Technical Service BULLETIN

Title: **1ZZ-FE ENGINE MOUNT** TAKEOFF VIBRATION

'05 - '06 Corolla & Matrix

EG027-06

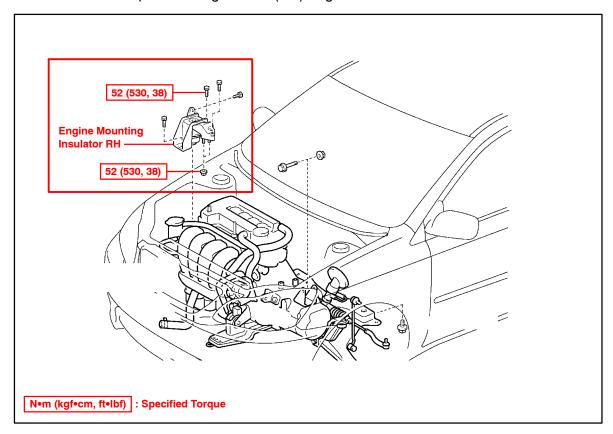
Some 2005 - 2006 model year Corolla and Matrix vehicles may exhibit engine vibration and drone noise while accelerating from a stop up to 30 mph. The right hand (RH) engine mount has been improved to correct this condition.

PREVIOUS PART NUMBER		CURRENT PART NUMBER	PART NAME	QTY	
	12305-0D022	12305-0D120	Engine Mount, RH	1

1. Remove and replace the right hand (RH) engine mount.
